# Rezoning Transportation Analysis

Petition Number: 2023-033

Date	Description
7-26-23	First Review (IW)
08-24-23	Second Review (NK)
9-20-23	Third Review (NK)
10-25-23	Fourth Review (NK)
11-27-23	Fifth Review (NK)

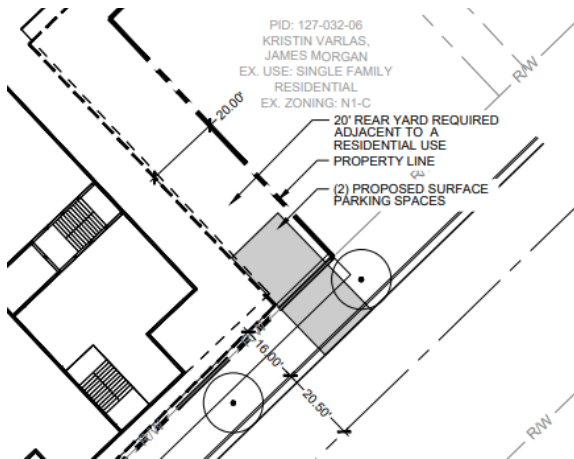
- ~~8. CDOT requests that the petitioner revise site plan and conditional note(s) to commit to upgrading the rapid flashing beacon pedestrian crossing at Clement Ave and E. 7<sup>th</sup> Street.~~

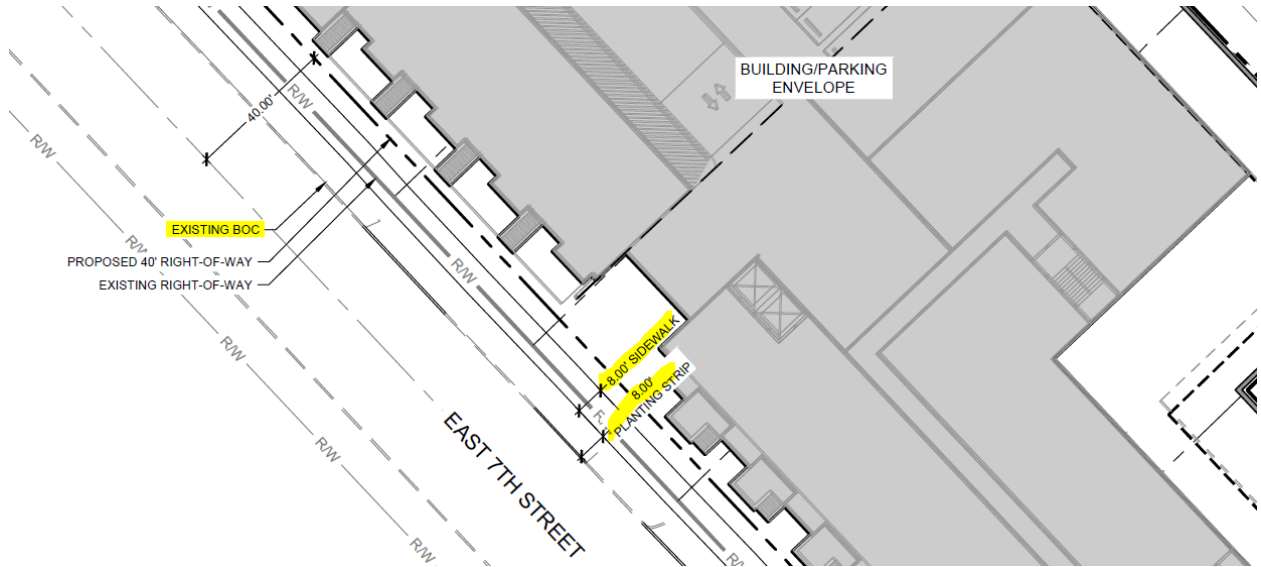
13. **New Comment 10-26-23:** Revise site plan to show future curb line located 27’ from centerline of E. 7<sup>th</sup> Street. Preservation of future curb line allows installation of bicycle facilities in the future to include buffered bicycle lanes. Preservation of space for future buffered bicycle lanes meets Council-adopted Charlotte BIKES policy. Current plan revision removed preservation of space for bicycle facilities and does not accommodate any form of future bicycle facilities.
